| Project | IEEE 802.16 Broadband Wireless Access Working Group < http://ieee802.org/16 > | |

| Title | Transmission of the last complete SDU without subheader | |

| Date Submitted | 2004-05-10 | |

IEEE C802.16e-04/80r1

Figure 1 "insufficient room in a MAC PDU"

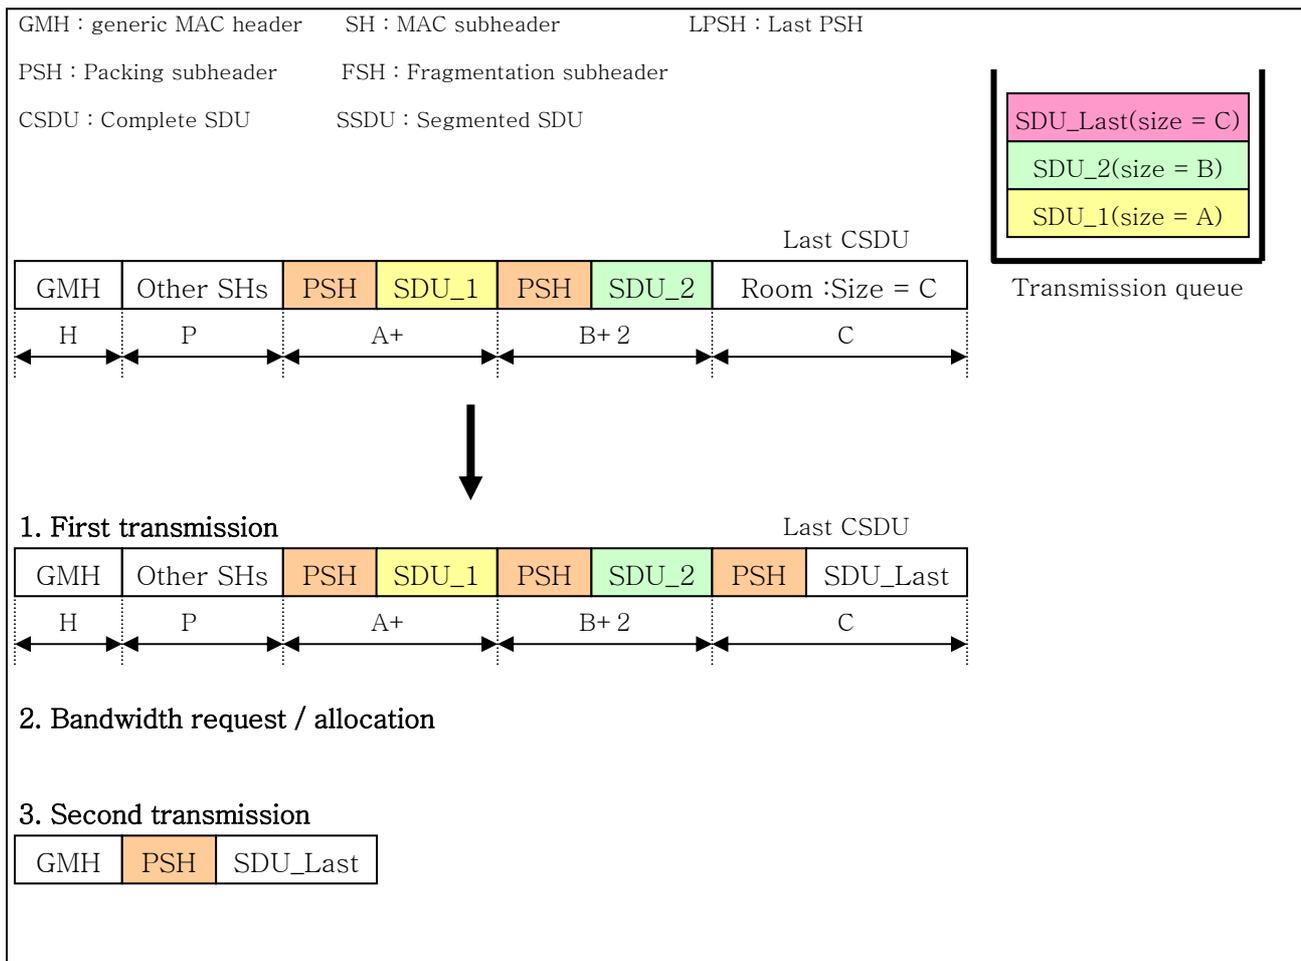
Now we can imagine the following situation shown in figure1. If the room of the MAC PDU is equal to 'C' ~ 'C + (PSH size - 1)', transmitter shall perform 1, 2, 3 in figure1.

Figure 2 "SDU_Last a MAC PDU/ Without packing subheader"

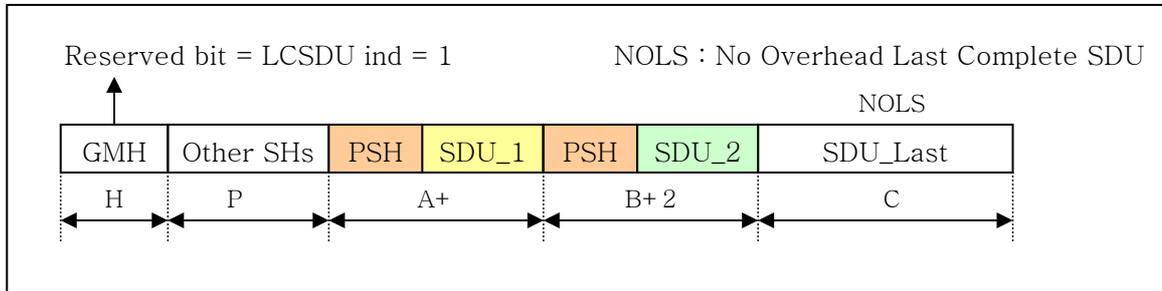
With the help of Figure 2 and Table 1, the transmitter is able to send the last complete SDU and the receiver is able to correctly receive the last SDU without a packing subheader.

As illustrated in Figure 2, when the remaining space for the MAC PDU payload is 'C' ~ 'C + (PSH size - 1)', transmitter shall set 'NOLS presence' = 1 and insert NOLS payload into the corresponding MAC PDU and the receiver shall decode the 'NOLS Presence' bit and unpack the NOLS payload from the received MAC PDU.
